Reference: BMAA Service Bulletin 2759 issue 1
Title: Upper port engine mounting bolt failure
Applicability: All UK (BMAA) Sky Ranger aircraft with Rotax 912-series engine
Author: Ben Syson, BMAA
Effective date: 1 July 2019
Classification: Advisory Service Bulletin

4 Bracing strap

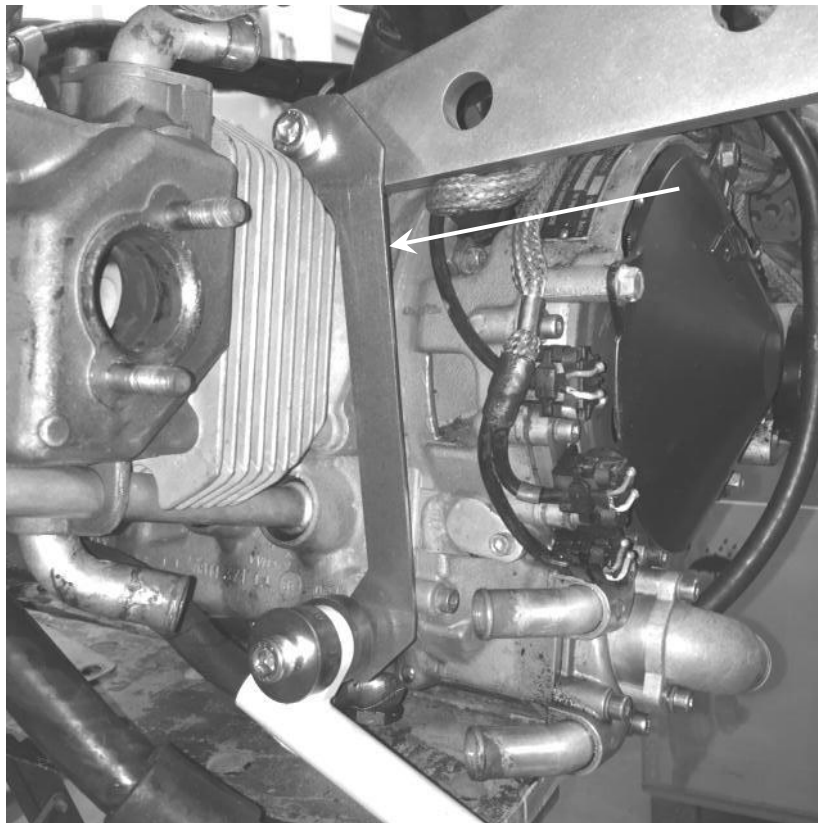
A bracing strap is available as an option which is intended to support the outside of the upper port mounting bolt to eliminate, or at least reduce, the bending loads that this bolt is subjected to. At the time of writing no failures of the upper port mounting bolt have been reported, but this modification does not yet have sufficient service experience to prove that it eliminates the problem.

The latest Build Manuals incorporate the bracing strap on Rotax 912ULS engine installations, which give the bolt a harder time than the Rotax 912UL engine. For existing Rotax 912ULS engined Sky Rangers that were built before this option was devised, it is recommended to fit the bracing strap at a suitable juncture such as the next major engine service. Use new anti-vibration mounts and mounting bolts. Build Manuals are available on the Sky Ranger website (www.skyranger.co.uk).
